Date: April 27, 2004
Refer to: ER2004-0225

SUBJECT: RESPONSE TO YOUR NOTICE OF DEFICIENCY (NOD) FOR THE COMPLETION REPORT FOR THE VOLUNTARY CORRECTIVE ACTION AT SOLID WASTE MANAGEMENT UNITS (SWMUs) 0-030(I), 0-033(a), AND 0-030(a) AND AOCs 0-004, 0-010(b), 0-033(b), AND 0-029(a,b,c).

**Response to Notice of Deficiency on the Completion Report for the Voluntary Corrective Action at
SWMUs 0-030(a), 0-030(b)-00, and 0-033(a), and AOCs 0-029(a,b,c), and 0-010(a,b), and for the
Interim Action at SWMU 21-021-99
Los Alamos National Laboratory, EPA ID# NM0890010515**

Figure 2.4-2. Inorganic chemicals detected above BVs at AOCs 0-004 and 0-033(b) and SWMU 0-030(I)

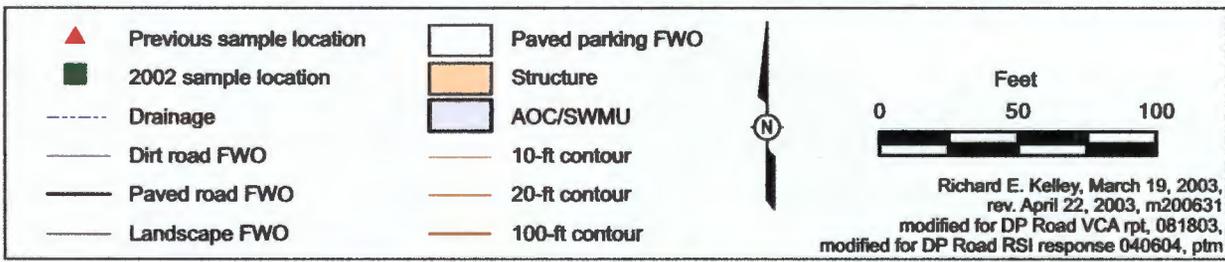
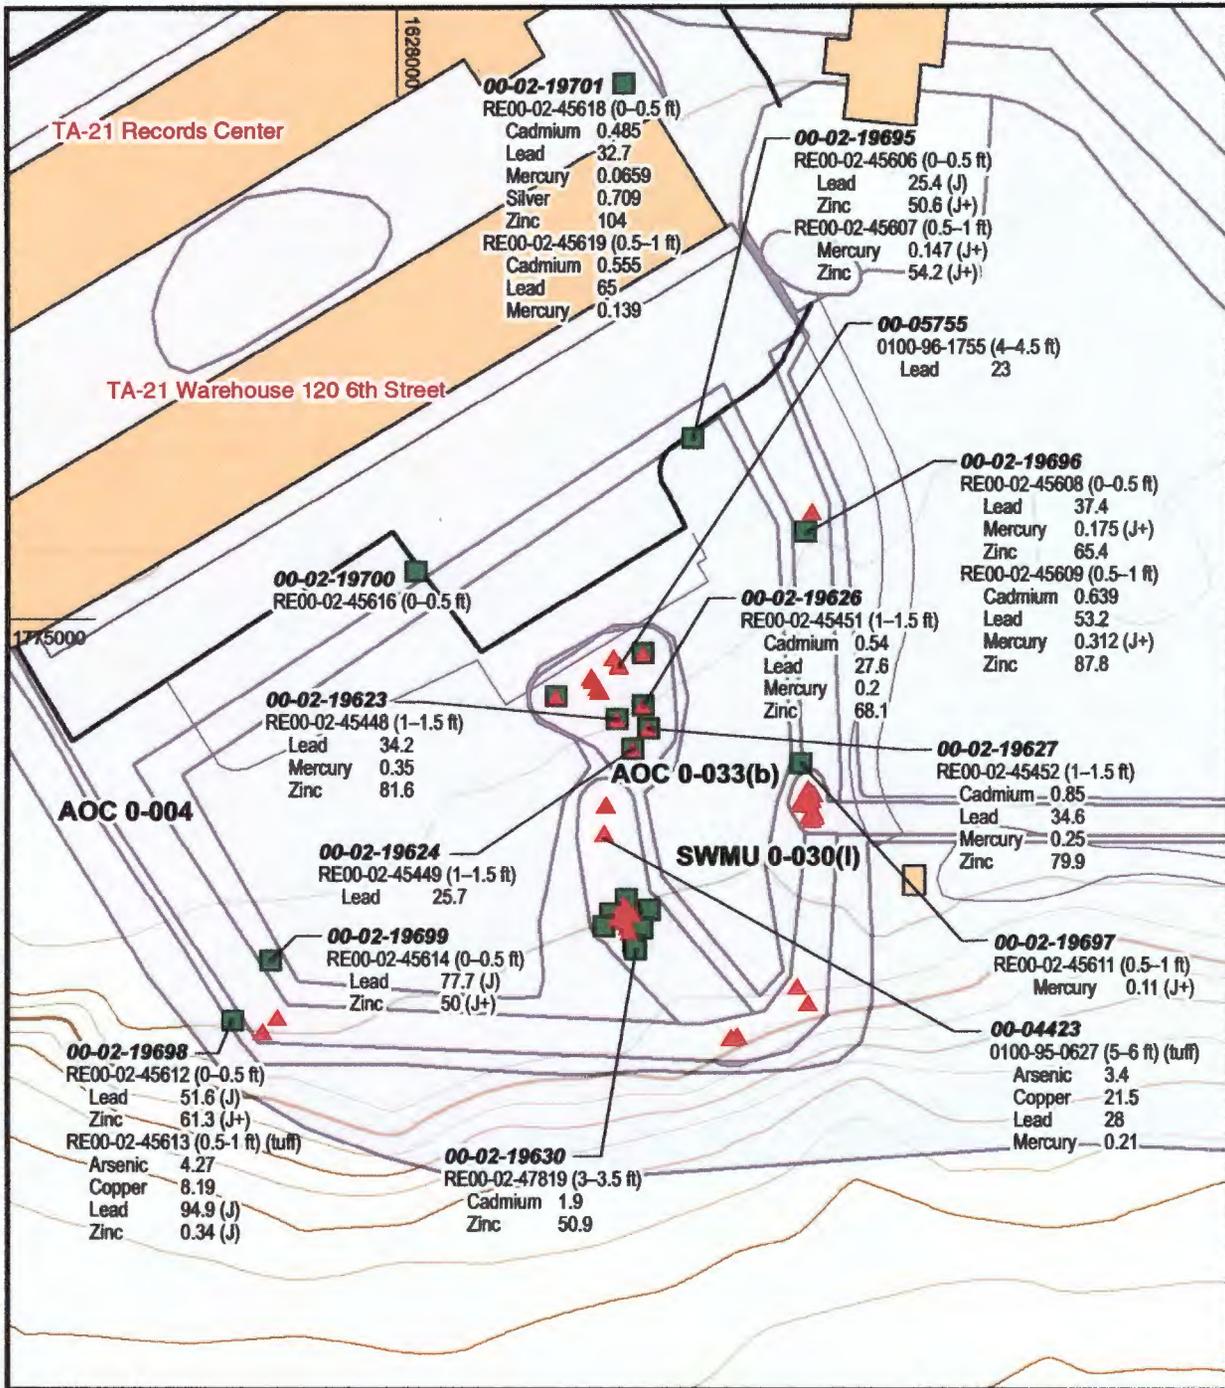
The Permittees must either remove the area of elevated concentrations of DDE/DDT at the southeast corner of the site or conduct additional sampling to determine the extent of contamination associated with the site. Based on the risk screening conducted for the site, removal of the surface soil within the drainage channel near the edge of the mesa (in the vicinity of sample locations 00-04223 and 00-04224) appears to be the most efficient corrective action alternative for the site. The ecological risk screening excluded this location from consideration in order to enable the site to pass the screening. If the Permittees propose to conduct additional sampling instead of site remediation, then shallow soil samples (0-1 ft) must be collected down gradient of the boundaries of the site where elevated concentrations of contaminants were detected, specifically at the southeast corner of the site. After conducting the required remediation or additional investigation at the site, then it will be appropriate to conduct a risk screening assessment for the site.

Sample location 00-04423 in Figure 2.4-2 was incorrectly located in the southeast corner of the aggregate. Sample location 00-04423 is actually part of SWMU 0-030(l). The figure has been revised and is provided as Attachment 1 to this notice of deficiency (NOD) response. Sample location 00-04423 will be sampled at depth at the same time as the soil removal and confirmatory sampling described above. The additional sampling will address the mercury concentration detected at 5–6 ft at this location (0.21 mg/kg) as well as other COPCs detected in this sample.

Figure 4.3-2. AOC 0-029(b) previous investigation sample locations

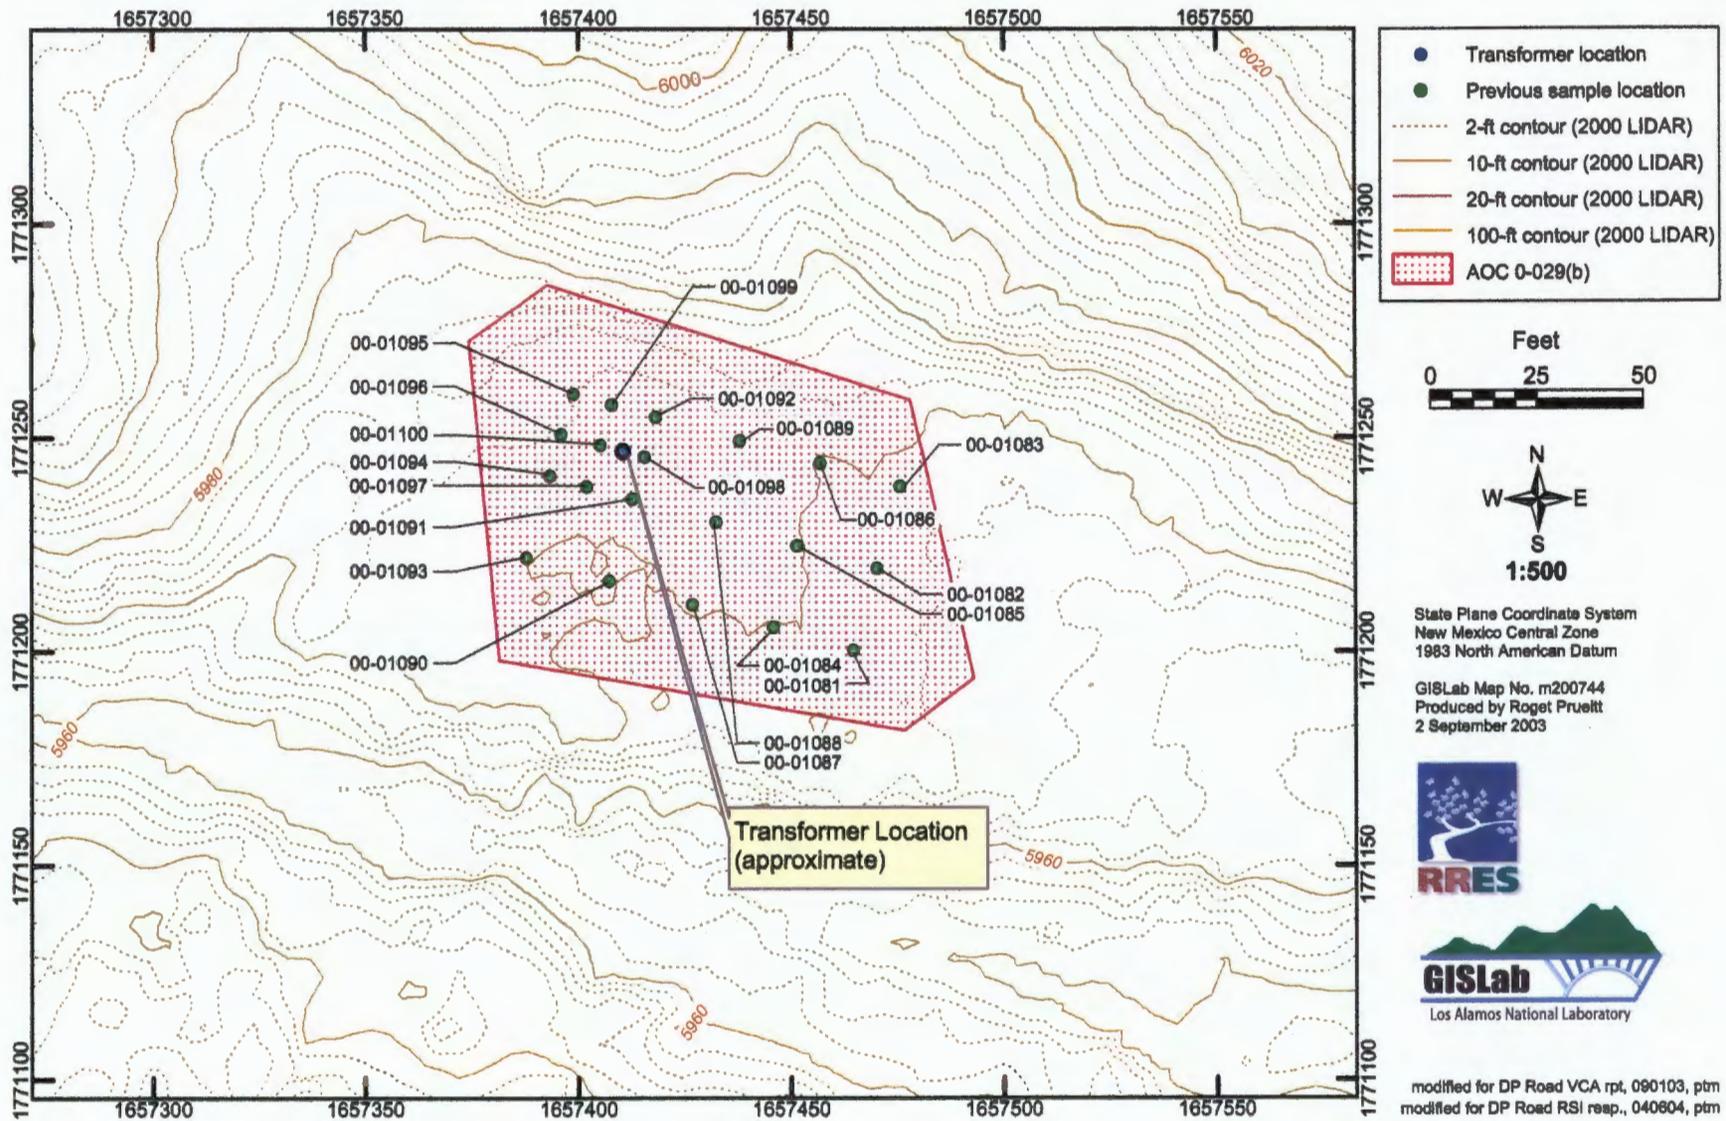
In addition, NMED cannot assess the data as it is currently presented. The two sample location maps in the document (Figure 4.3-2: previous investigation sample locations and Figure 4.4-2: RFI and VCA sample locations) do not match. Neither the coordinates of the AOC nor the shape of the AOC are the same on the two figures. The Permittees must provide maps with accurate sample collection locations to NMED. The Permittees must provide the coordinates of the sample locations and the structure locations (pump house and transformer). NMED cannot determine from the information presented in the report whether samples were collected in the proper locations.

Coordinates on Figure 4.3-2 have been corrected. The shape of the AOC in the two figures reflects the sample locations shown. Figure 4.3-2 shows the previously collected samples, while the shape of Figure 4.4-2 has been revised to show all sample locations. It should be noted that Figure 4.4-2 correctly shows both the recent sample locations and those shown (incorrectly) in Figure 4.3-2. Precise coordinates for the transformer location cannot be provided because it was not surveyed in 1992, and the pole was not present in 2002. A revised Figure 4.3-2 is included as Attachment 3.

Figure 4.3-3. AOC 0-029(c) previous investigation sample locations

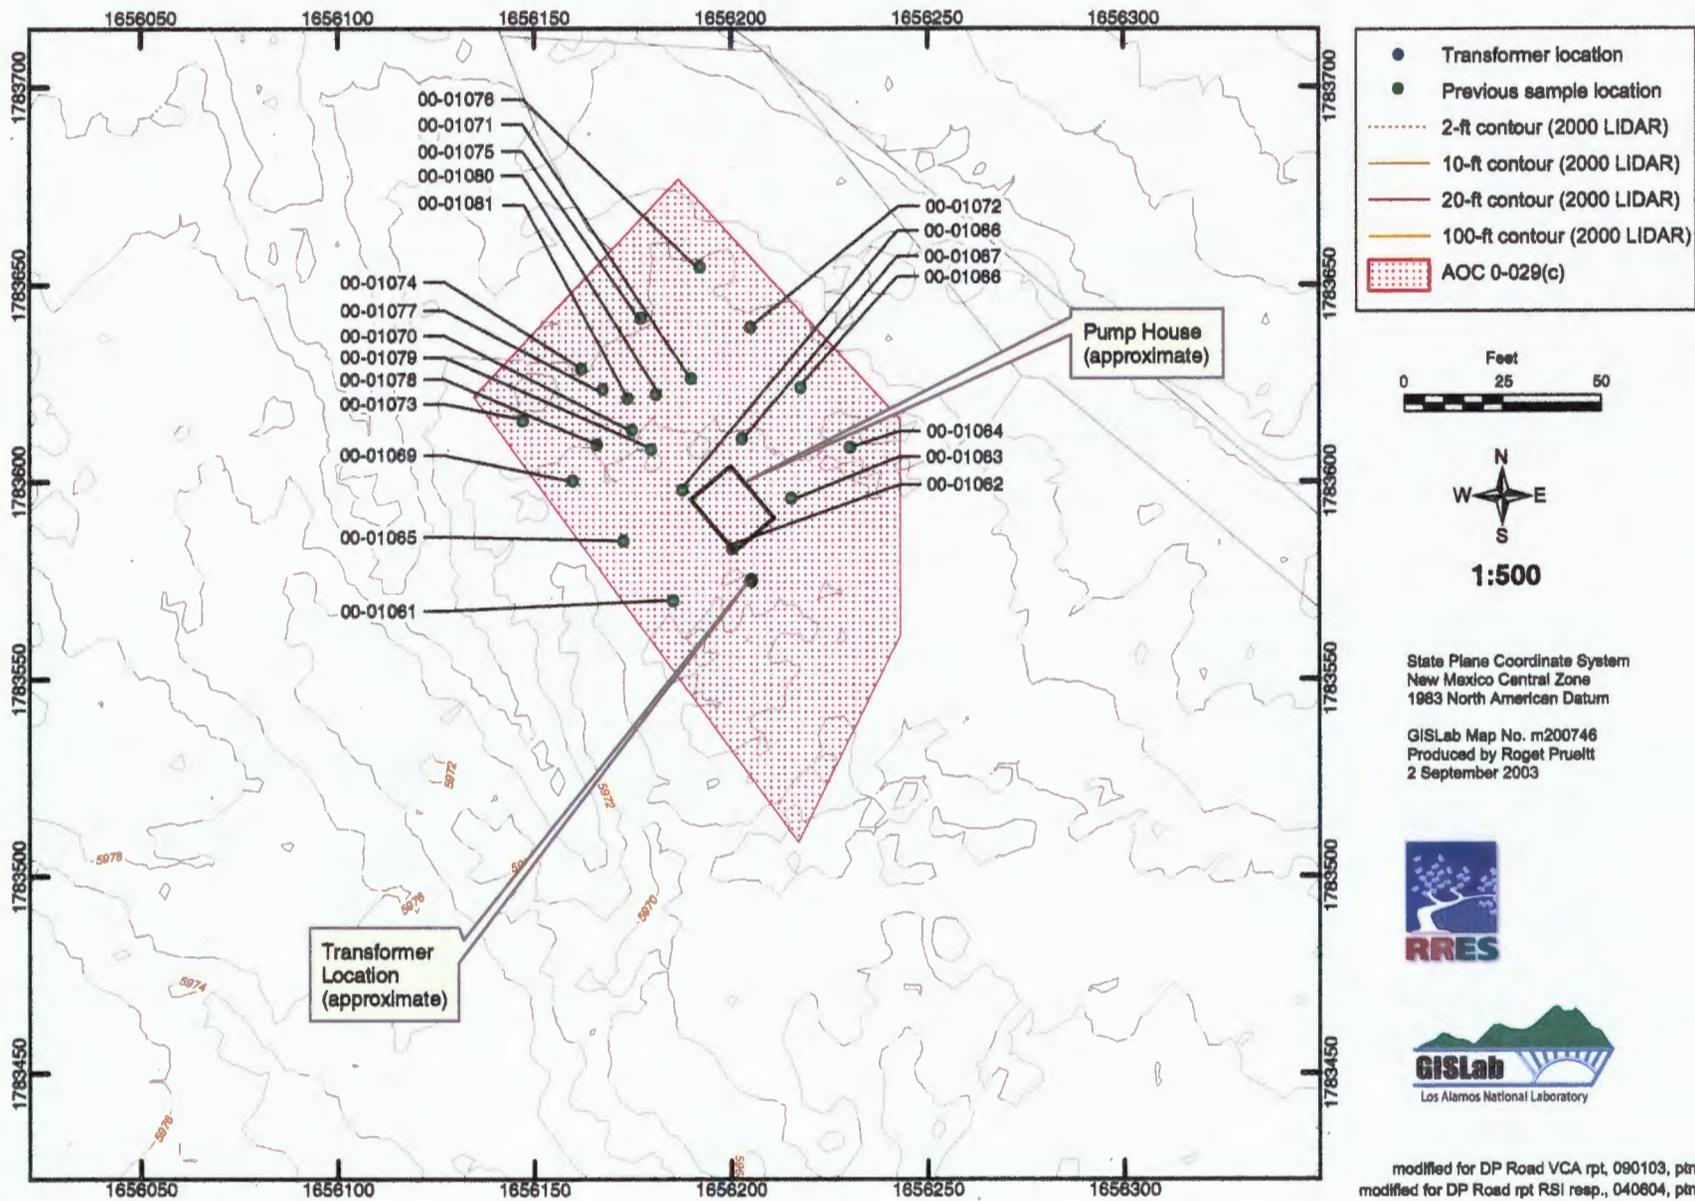
In addition, NMED cannot assess the data as it is currently presented. The two sample location maps in the document (Figure 4.3-3: previous investigation sample locations and Figure 4.4-3: RFI and VCA sample locations) do not match. Neither the coordinates of the AOC nor the shape of the AOC are the same on the two figures. The transformer is not located in the same place in relation to the pump house on the two figures. In Figure 4.3-3, the transformer is located northwest of the pump house, but in Figure 4.4-3 the transformer is located south of the pump house. The Permittees must provide maps with accurate sample collection locations to NMED. The Permittees must provide the coordinates of the sample locations and the structure locations (pump house and transformer). NMED cannot determine from the information presented in the report whether samples were collected in the proper locations.

Figure 4.3-3 is based on incorrect coordinates that were later corrected and included in Figure 4.4-3. Figure 4.3-3 will be corrected. Figure 4.4-3 is correct as provided, and includes all sample locations and the correct (approximate) locations of the pump house and transformer. Precise coordinates for the pump house and transformer locations cannot be provided because they were not surveyed in 1992, and the structures were not present in 2002. A revised Figure 4.3-3 is included as Attachment 4.

Figure 2.4-2. Inorganic chemicals detected above BVs at AOCs 0-004 and 0-033(b) and SWMU 0-030(I)

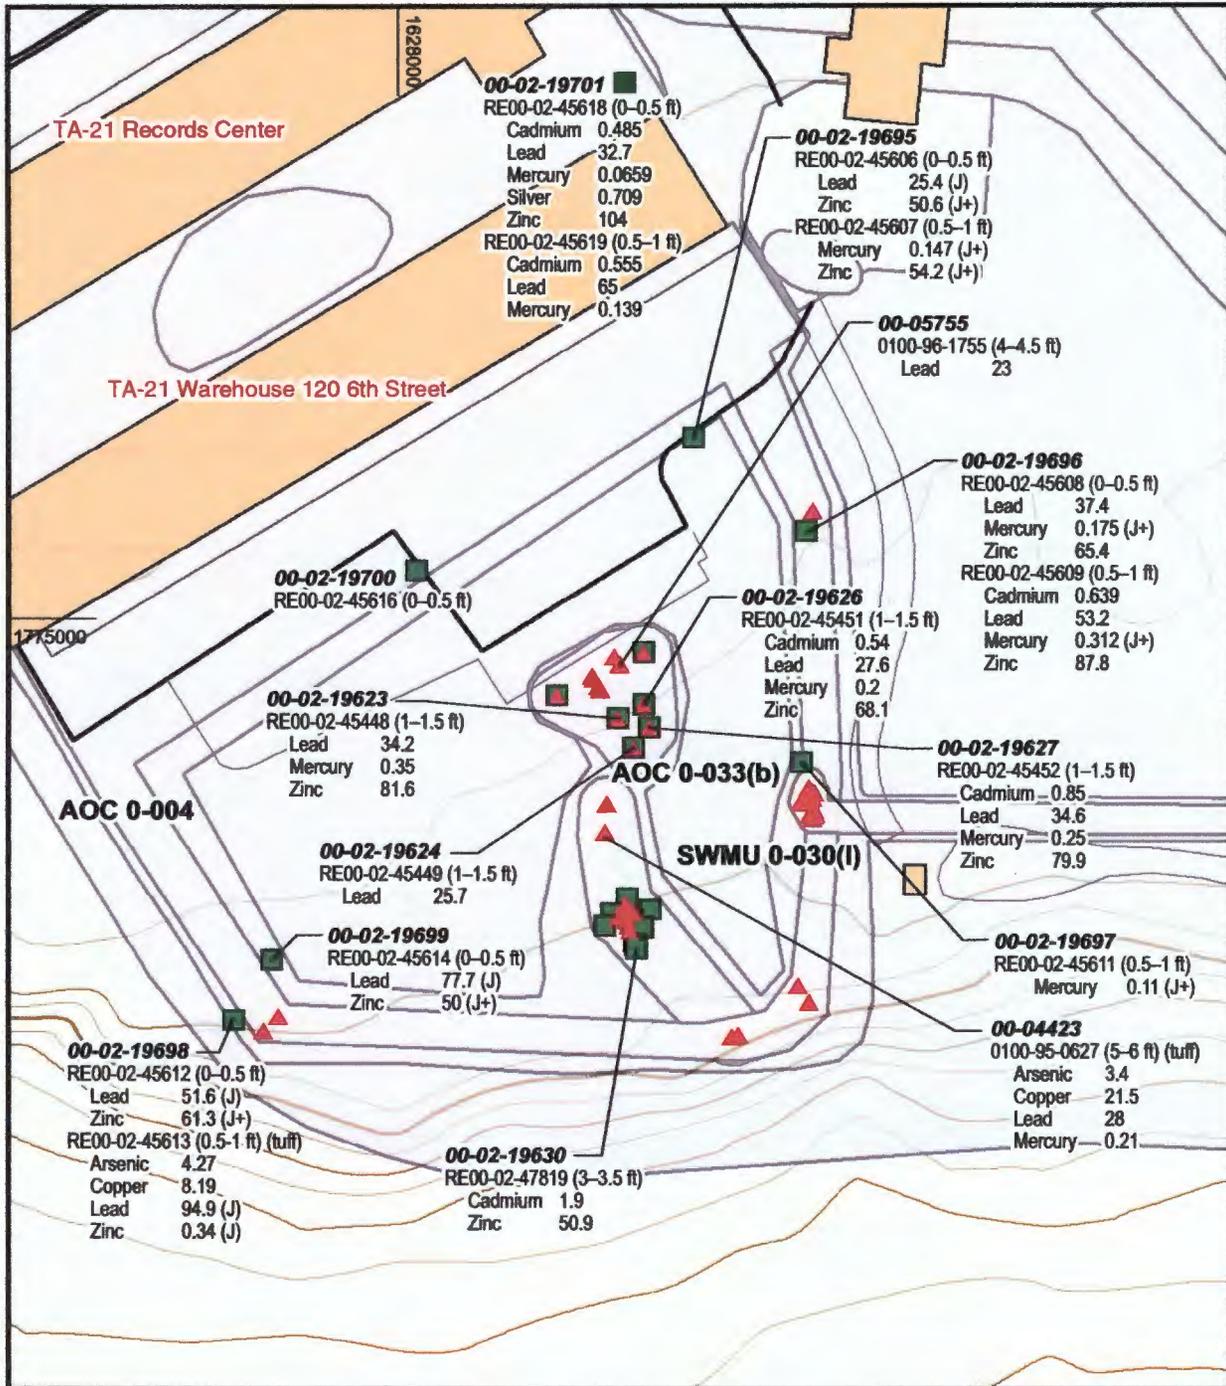
The Permittees must either remove the area of elevated concentrations of DDE/DDT at the southeast corner of the site or conduct additional sampling to determine the extent of contamination associated with the site. Based on the risk screening conducted for the site, removal of the surface soil within the drainage channel near the edge of the mesa (in the vicinity of sample locations 00-04223 and 00-04224) appears to be the most efficient corrective action alternative for the site. The ecological risk screening excluded this location from consideration in order to enable the site to pass the screening. If the Permittees propose to conduct additional sampling instead of site remediation, then shallow soil samples (0-1 ft) must be collected down gradient of the boundaries of the site where elevated concentrations of contaminants were detected, specifically at the southeast corner of the site. After conducting the required remediation or additional investigation at the site, then it will be appropriate to conduct a risk screening assessment for the site.

Sample location 00-04423 in Figure 2.4-2 was incorrectly located in the southeast corner of the aggregate. Sample location 00-04423 is actually part of SWMU 0-030(l). The figure has been revised and is provided as Attachment 1 to this notice of deficiency (NOD) response. Sample location 00-04423 will be sampled at depth at the same time as the soil removal and confirmatory sampling described above. The additional sampling will address the mercury concentration detected at 5–6 ft at this location (0.21 mg/kg) as well as other COPCs detected in this sample.
